# SHORT SUBDIVISION (RURAL) FORM

## RE: Proposed Sealock Short Plat 201025-13001

PRELIMINARY SHORT PLAT  
OF PARENT PARCEL 201025-13001 PREPARED FOR  
PHILIP SEALOCK  
300 JENSEN ROAD TOPPENISH, WA. 98948

RE: Wells and water systems for a future subdivision on parcel 201025-13001, located at 460 Chambers Road, Toppenish.

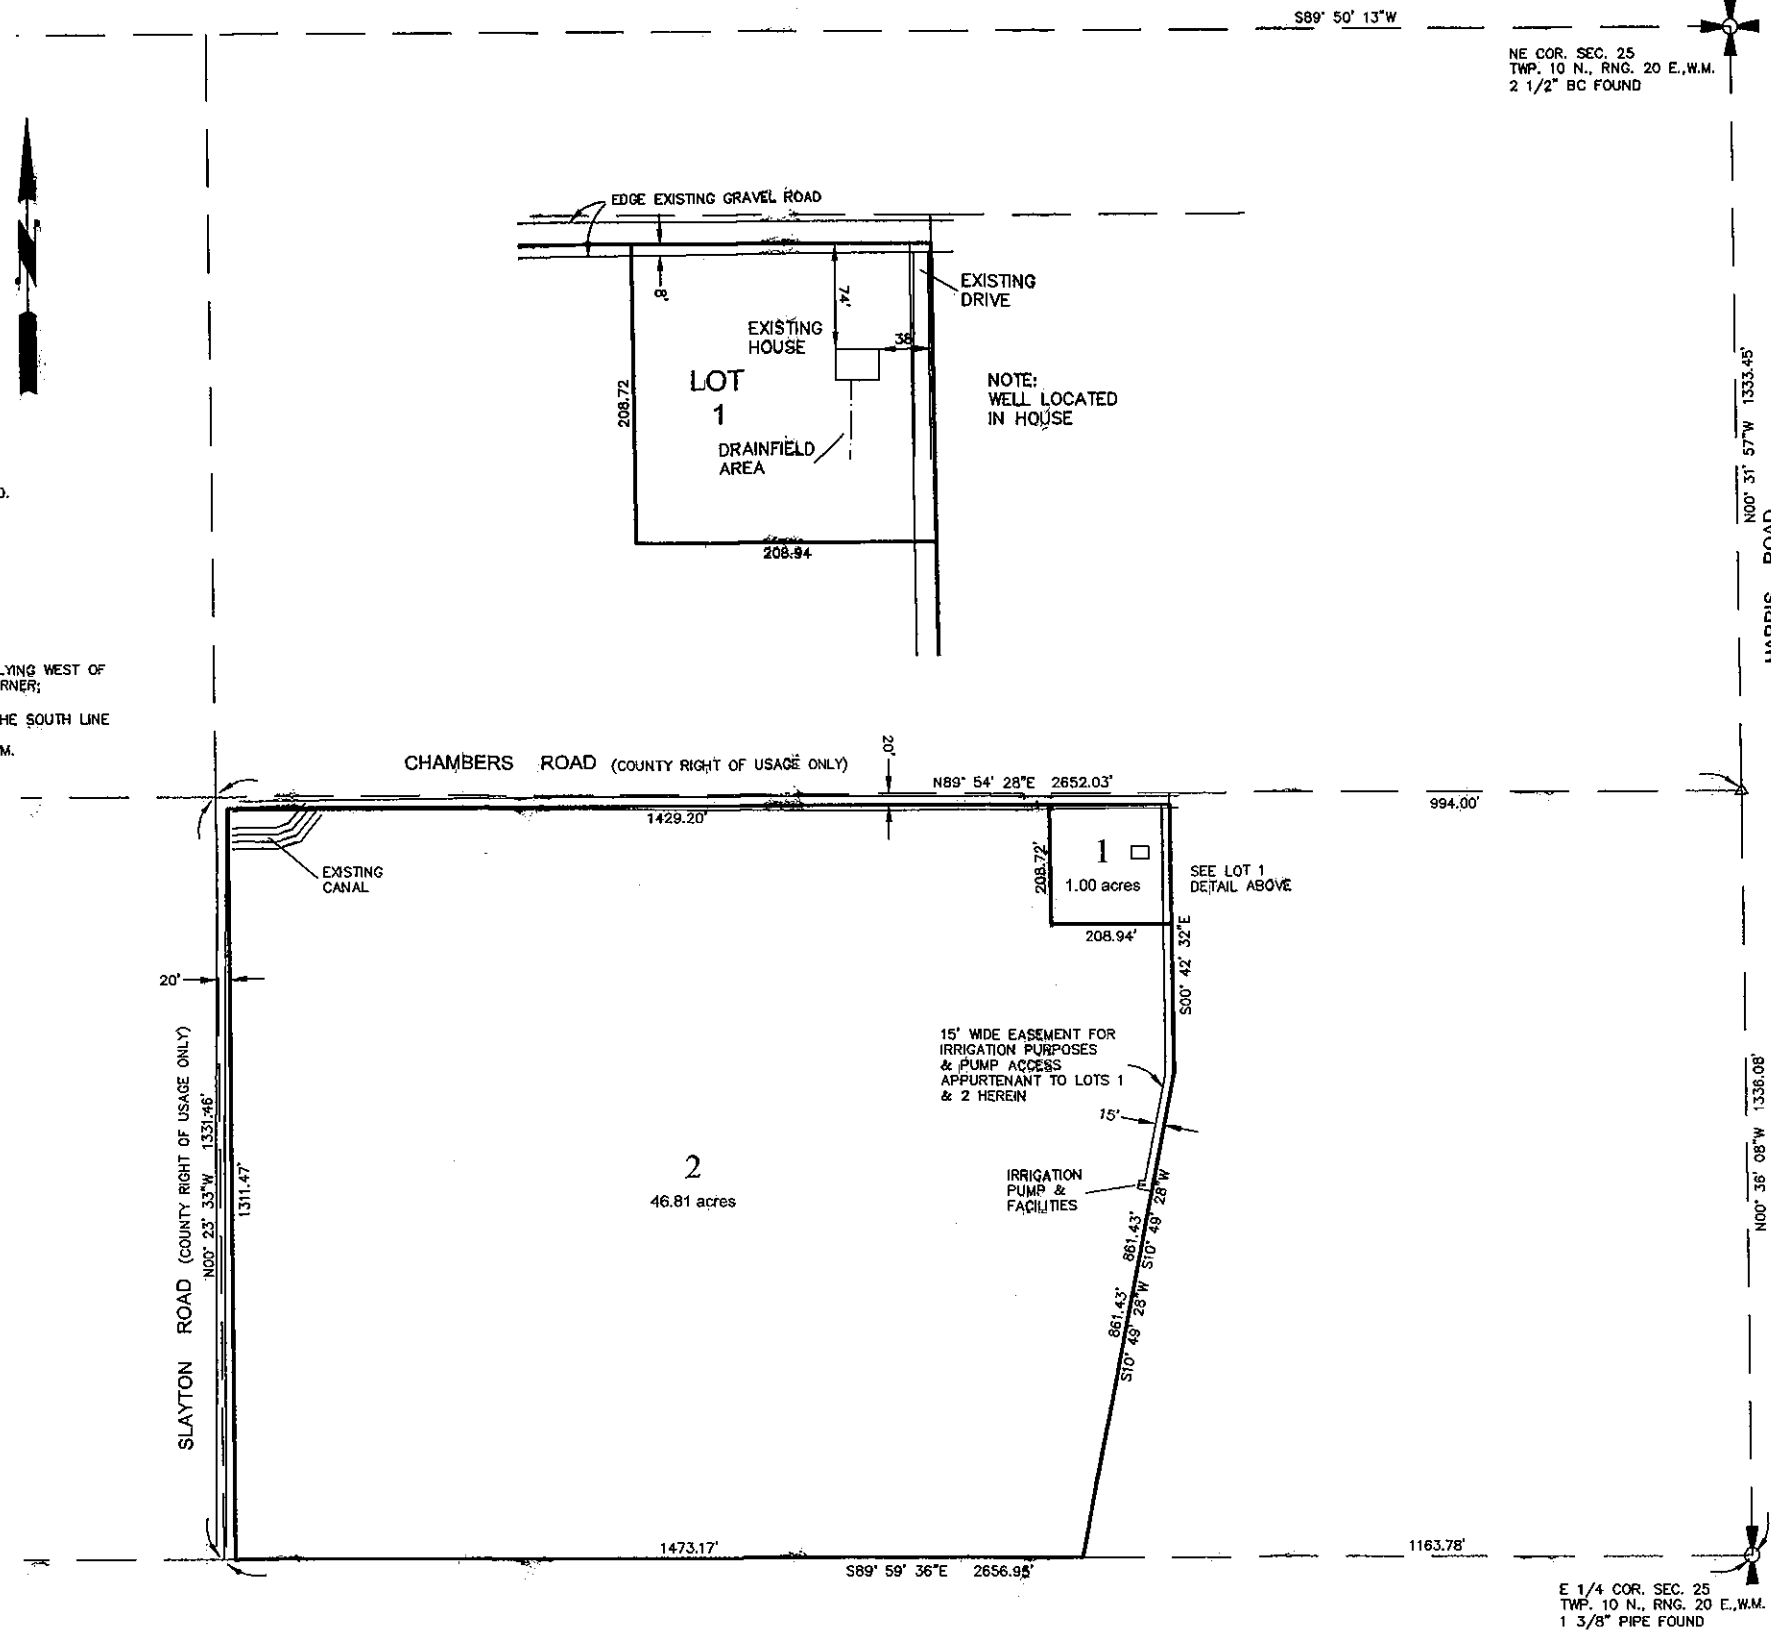
Parcel 20102513001 fronts Chambers and Slayton Road.

Slayton Road Functional Class: 09 Rural Local Access. R/W In place: 0 Additional R/W to be dedicated: 30' from center alignment

Chambers Road Functional Class: 09 Rural Local Access R/W In place 0 : Additional R/W to be dedicated: 30' from center alignment

Neither roads are up to the minimum design standard. Both will need to be improved to the minimum design standards of YCC 19.23.45 from the furthest affected part of the land development to the nearest paved road.

(Paved, 20 year lifespan, ASSHTO Standards, Designed by engineer, 2 Lanes, 11 foot lanes, 4' shoulder)

(B) Gravel. Where development is served by a gravel rural access road, the roadway shall be improved to current adopted County road standards along the entire frontage of the property. A financial contribution, in lieu of frontage improvements, may be proposed for consideration by the County Engineer. No design modification for surface type will be granted.

(iv) Be extended by the developer to and through the proposed development.
